THORNEYCROFT SUBDIVISION

APPLICATION NUMBER 1 DATE February 18, 2010

REQUEST Subdivision

PROPOSED SITE PLAN

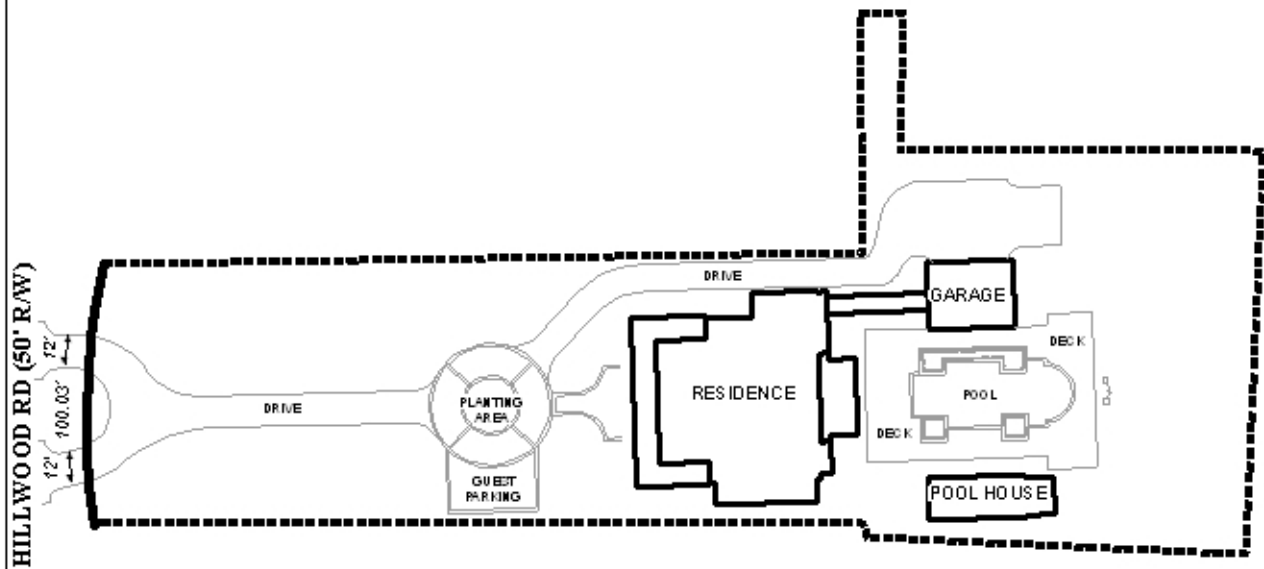
The plat meets the minimum size requirement for developments with access to public water and sewer. However, it is requested that the applicant revise the preliminary plat to label the lot with its size in square feet, or provide a table on the plat with the same information. The applicant should also revise the plat to illustrate the minimum building setback line from Hillwood Road.

- 2) labeling of each lot with its size in square feet, or the provision of a table on the final plat with the same information;
- 3) the depiction on the final plat of the 25' minimum building setback line along Hillwood Road;

- 2) *labeling of each lot with its size in square feet, or the provision of a table on the final plat with the same information;*
- 3) *the depiction on the Final Plat of the 25' minimum building setback line along Hillwood Road;*
